Regarding: 07V-219

Technical BULLETIN

RECALL This modification has top priority. This bulletin must be performed immediately to ensure customer safety.

'05~'07 YP400; '06~'07 CP250; '07 XF50 FACTORY MODIFICATION CAMPAIGN – Fuel Pump Seal

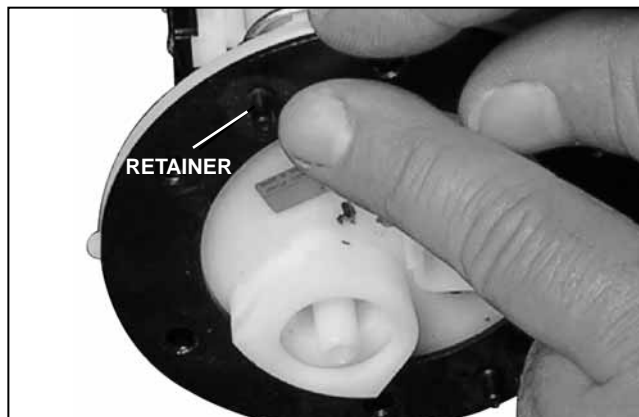
4. Place the fuel pump upside down on a work surface that is free of any dirt or debris that could contaminate the fuel pump or enter the fuel outlet. Remove the fuel pump seal from the fuel pump.

5. Install the new fuel pump seal on the fuel pump. Pull the fuel pump seal retainers through their respective holes in the fuel pump and metal ring.
6. Reinstall the fuel pump. Be sure the alignment projection on the fuel pump faces the alignment mark on the fuel tank (towards left rear).

Tighten the 6 fuel pump retaining bolts in an **even crisscross pattern** and torque the bolts to 4 Nm (0.4 m • kg, 2.9 ft • lb). Reinstall the fuel hose cap and harness coupler; they should click into place when properly installed.

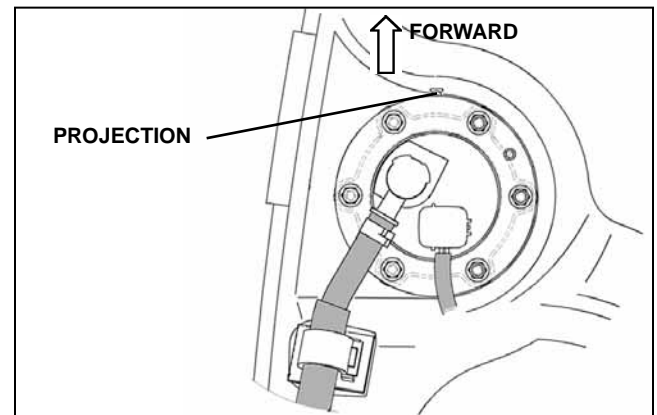
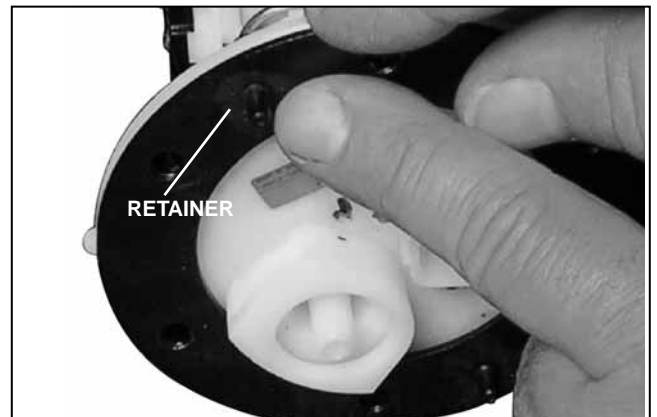
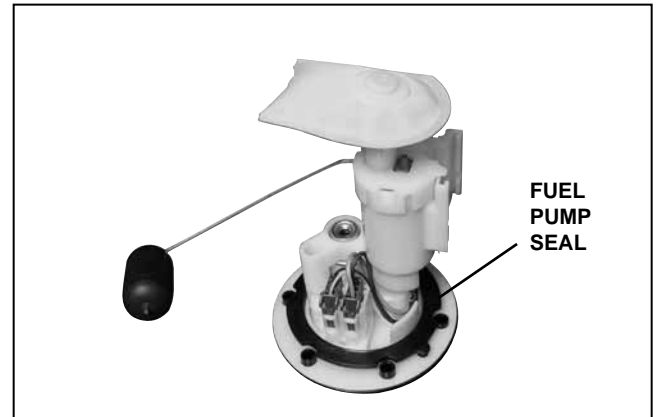
- Place the fuel pump upside down on a work surface that is free of any dirt or debris that could contaminate the fuel pump or enter the fuel outlet. Remove the fuel pump seal from the fuel pump.

- Install the new fuel pump seal on the fuel pump. Pull the fuel pump seal retainers through their respective holes in the fuel pump and metal ring.

- Position the fuel pump back on the fuel tank. Be sure the alignment projection on the fuel pump faces forward.

Tighten the 6 fuel pump retaining bolts in an **even crisscross pattern** and torque the bolts to 4 Nm (0.4 m·kg, 2.9 ft·lb). Reinstall the fuel hose cap and harness coupler; they should click into place when properly installed.

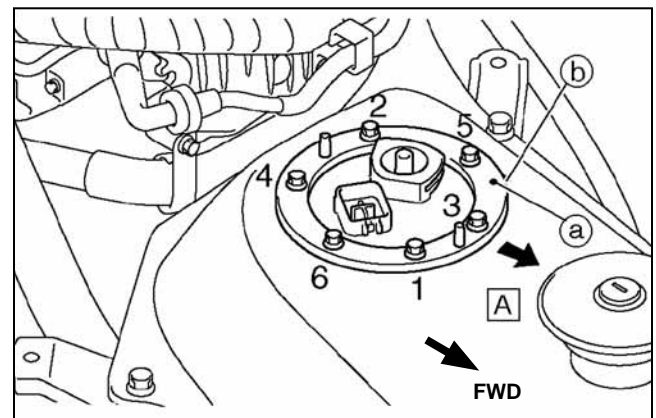
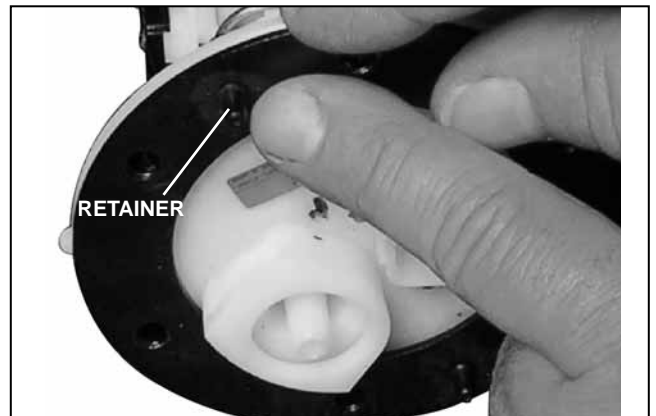
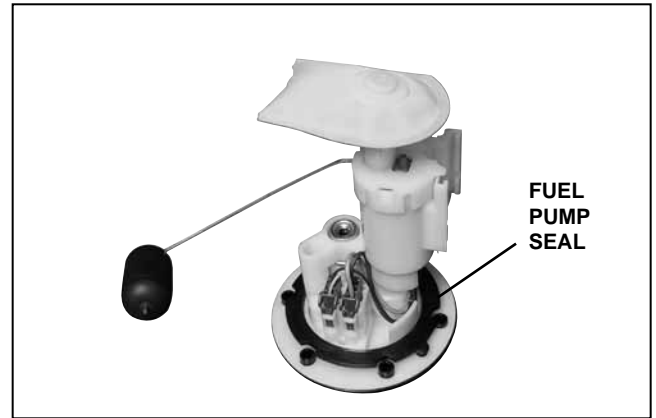
- Place the fuel pump upside down on a work surface that is free of any dirt or debris that could contaminate the fuel pump or enter the fuel outlet. Remove the fuel pump seal from the fuel pump.

- Install the new fuel pump seal on the fuel pump. Pull the fuel pump seal retainers through their respective holes in the fuel pump and metal ring.
- Position the fuel pump back on the fuel tank. Be sure the alignment projection on the fuel pump (a) faces alignment mark (b) in the fuel tank.

Tighten the 6 fuel pump retaining bolts in an **even crisscross pattern** and torque the bolts to 4 Nm (0.4 m • kg, 2.9 ft • lb).
